GN933x changes

NOTE: ONLY CHANGES IN THE HEADSET. NO CHANGES IN THE BASE

Figure 1: Current antenna placement

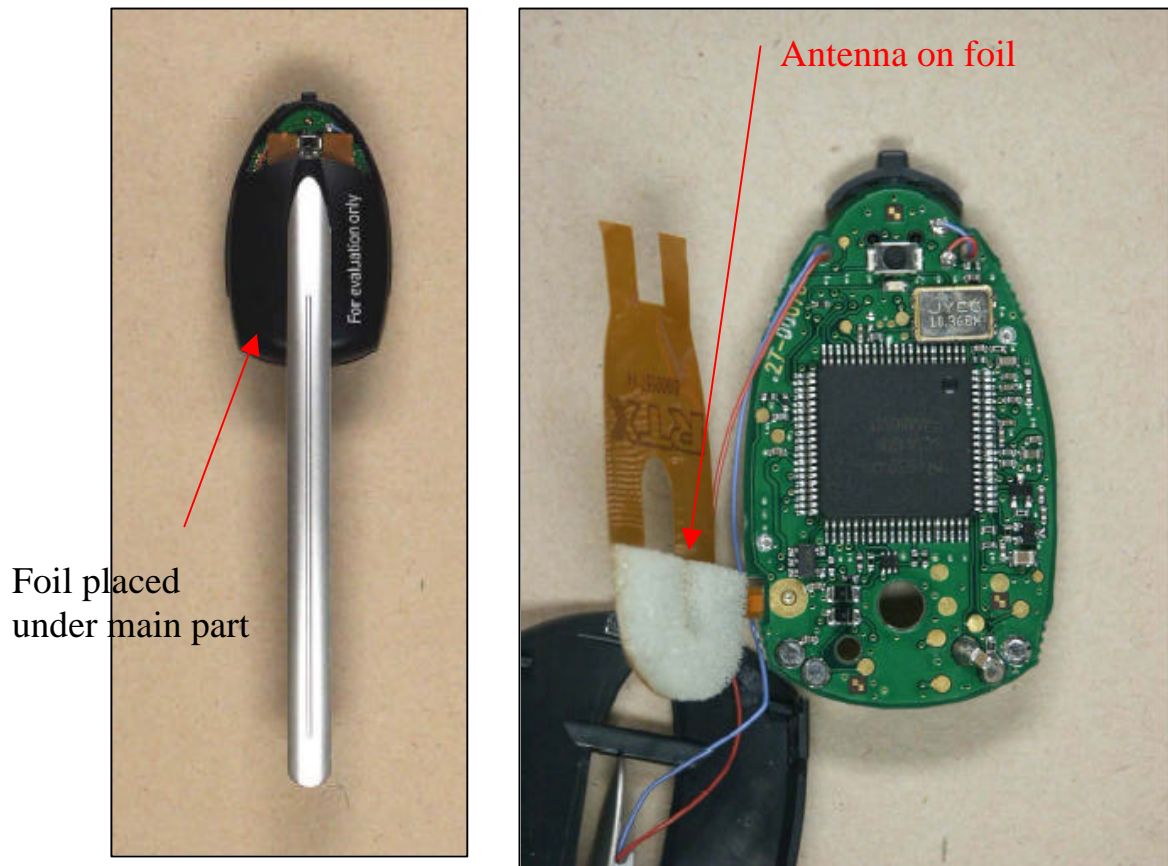
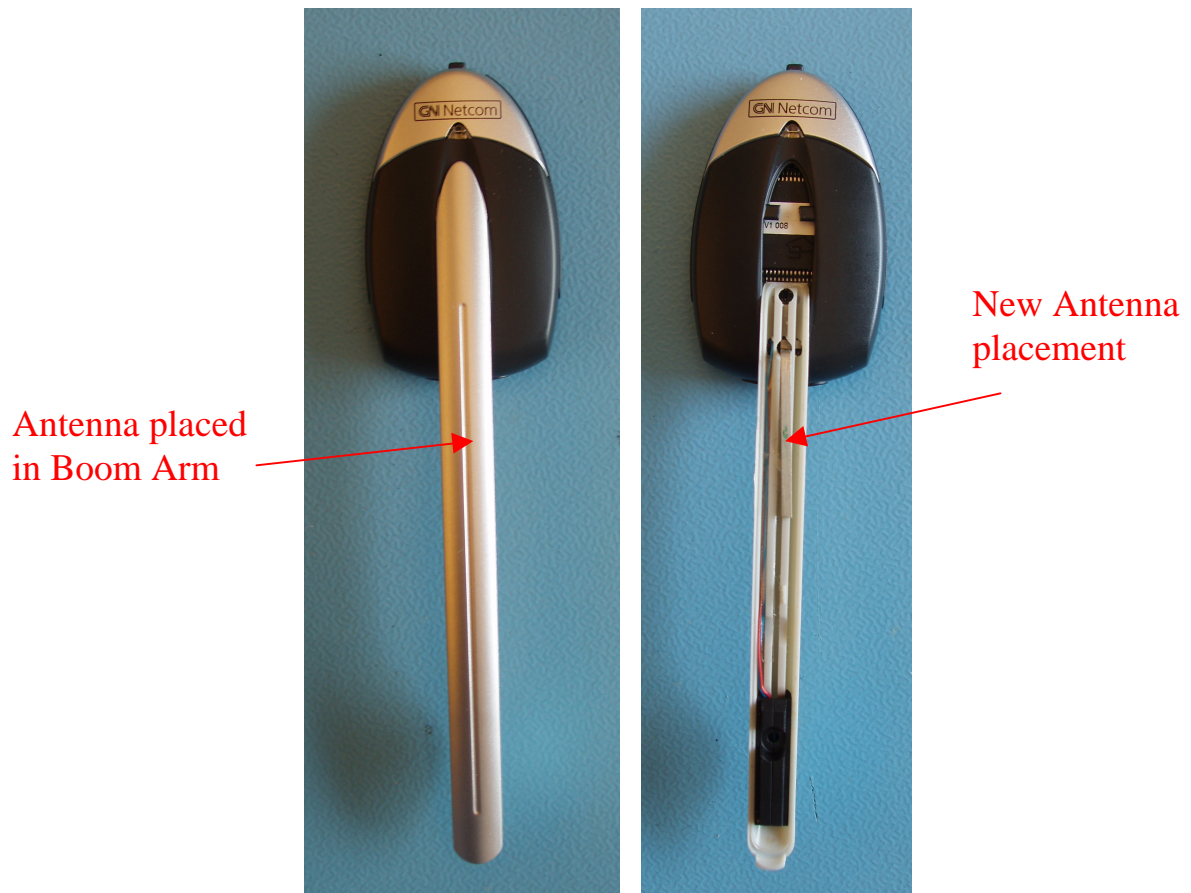
The placement of the antenna in the GN93xx headset has changes. In the current solution it is a foil placed inside the main part of the headset, see Figure 1.

In the new solution it is a small metal strip placed inside the Boom Arm (silver part), see Figure 2.

Current Design – Top side

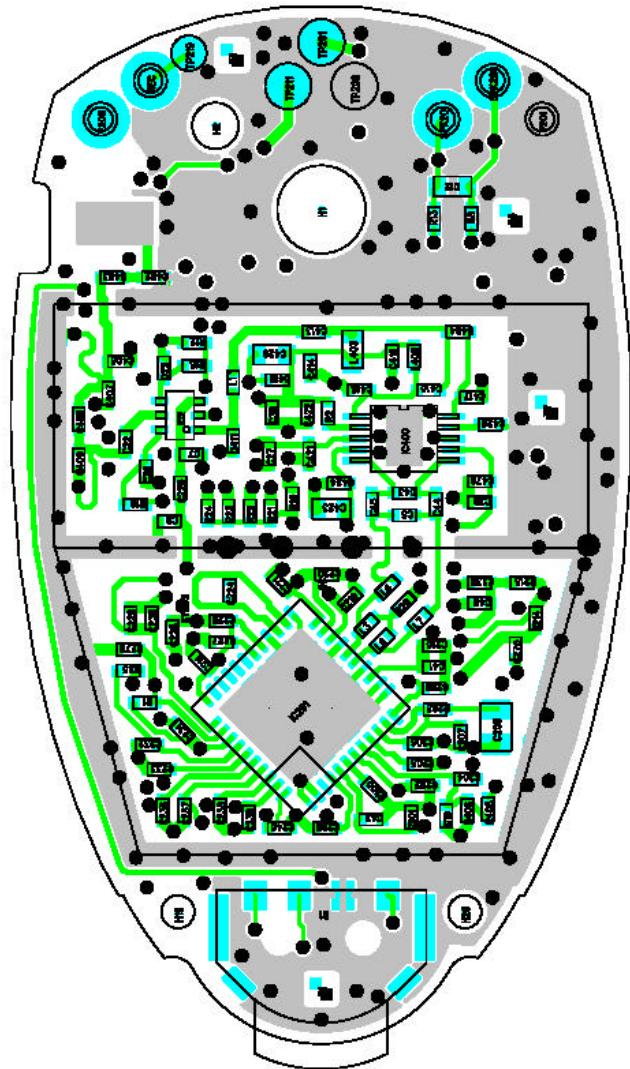
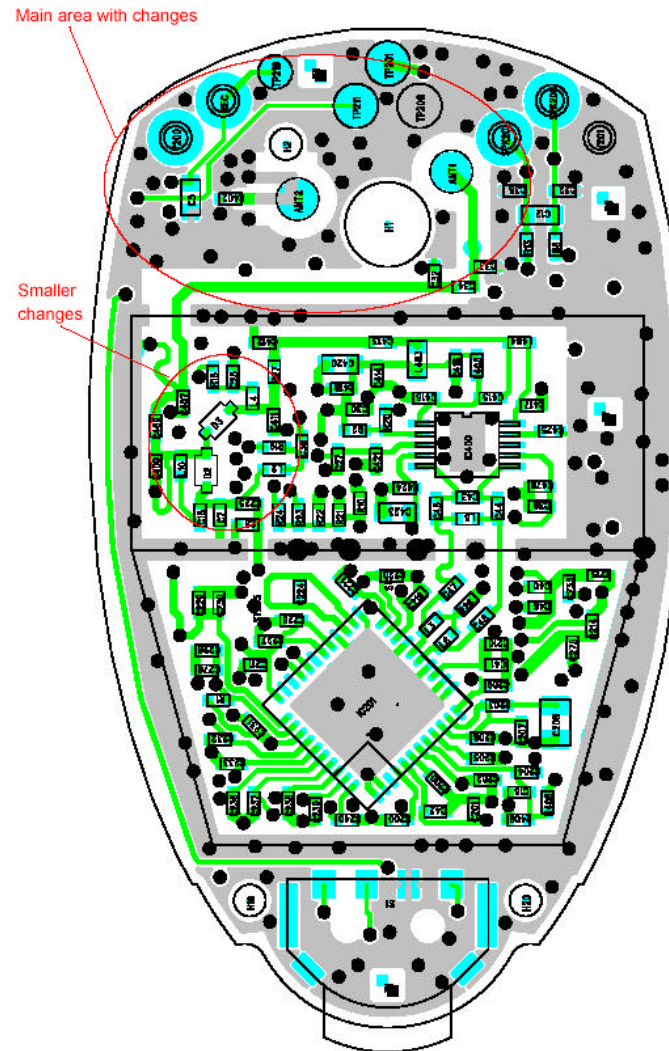
As the antenna has changed, small changes in the PCB layout around the antenna have been needed. The main part of the layout is similar to the one in the GN93xx headsets found on the market today. Figure 3 shows the area with changes.
